# Access Compliance Report

## Public Rights-of-Way

### (Pedestrian Signals)

Intersection ID: N/A	Main Street:	Cross Street: N/A	Location: N/A
ADA ID: D22552D0532F	Signal Type: One Push Button-Non APS	Overall Compliance: No	Severity Score: BTN 1: N/A BTN 2: N/A No BTN: N/A
Codes/Mitigation Info/Possible Solution		Field Measurements/Component Compliance

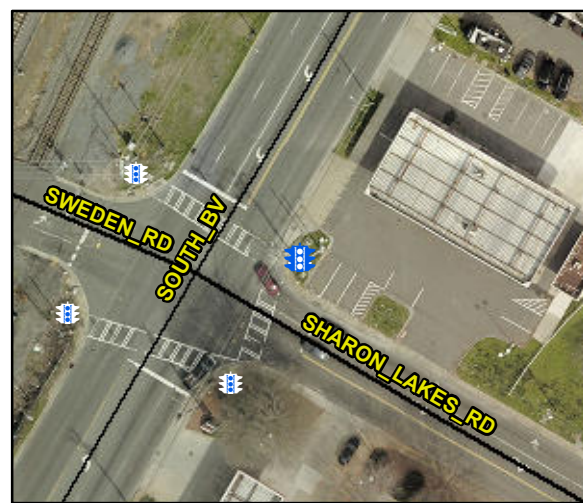
Possible Solutions: Provide PAR As Indicated. Provide Push Button Extension. Remove and Replace Clear Space.

PROW/ADA: R404.3, R404.2, R406.2
